*Proceedings of the Madras Government, Public Works Department,
10th March 1874.*

Note by the Chief Engineer for Irrigation.

CHINNADÉVALAPURAM TUMMALA TANK.

Report to accompany estimate for raising the bund and repairing the calingulah and two sluices.

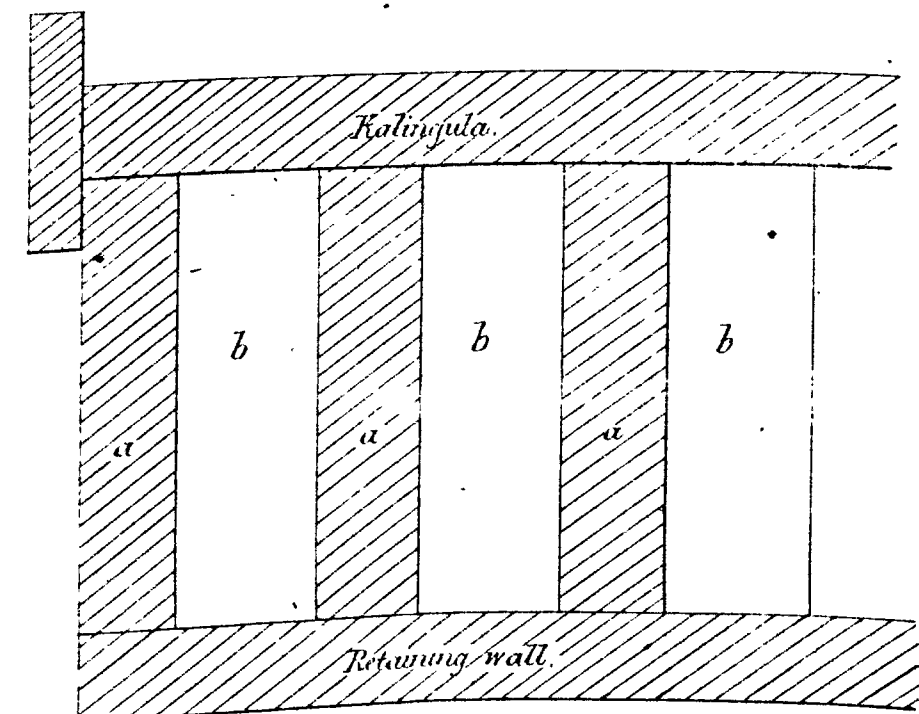
The top of the bund is to be picked up and watered before the fresh earth is laid on, and the outer slope to be cut into steps as drawn. The upper part of the tamped, The remainder to be laid in similar layers and tamped but need not be watered.

The work is to be commenced at the bottom and carried up layer by layer to the top, the layers sloping slightly inwards towards the bund. The wet and dry tamped work must be carefully united.

THE estimate for the Chinnadevalapuram Tank has been carefully prepared, and the work proposed to be done is not in excess of the requirements. The amount however, Rupees 3,200 is large, owing to four annas a cubic yard being entered for earthwork watered and tamped, and two annas for such work without water. The reason given for the four anna rate is that water will probably have to be brought half a mile. In paragraph 7 of the report it will be seen that there was water in the tank when the estimate was prepared, and probably it will be obtainable at no great distance from the surface. If not the repairs should be confined for the present to those portions which are less than one foot or fifteen inches above maximum water level, or three feet three inches above escape weir crest level, and the rest of the work should be completed when water is available in the tank. Two and a half annas a cubic yard should be the maximum rate for watered earthwork, other than that which may have to be done with water brought from a long distance, and ten cubic yards a rupee, with three pias a cubic yard for tamping, should suffice for the dry earthwork. Wherever the maximum water line is above the present top of the bund, a longitudinal trench should be cut in the latter, or there will be risk of dangerous leakage. The stepping shown in the cross sections on the rear slope of the bund is inadequate; a mere roughing will not do, but steps at least two feet wide with a slight slope* towards the inside of the tank.

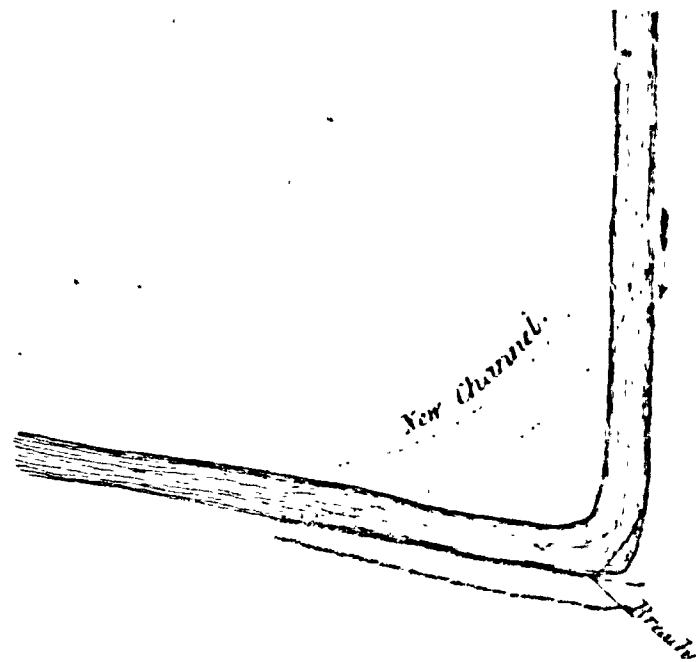
8. If these works are carefully carried out the tank will be put into a good and safe condition and no further repairs should be required for many years. The supply channel has, near the tank, a sudden bend, nearly 90 degrees, and at this place a breach occurs almost every year. It is now proposed to convert it into an easy curve thus:—
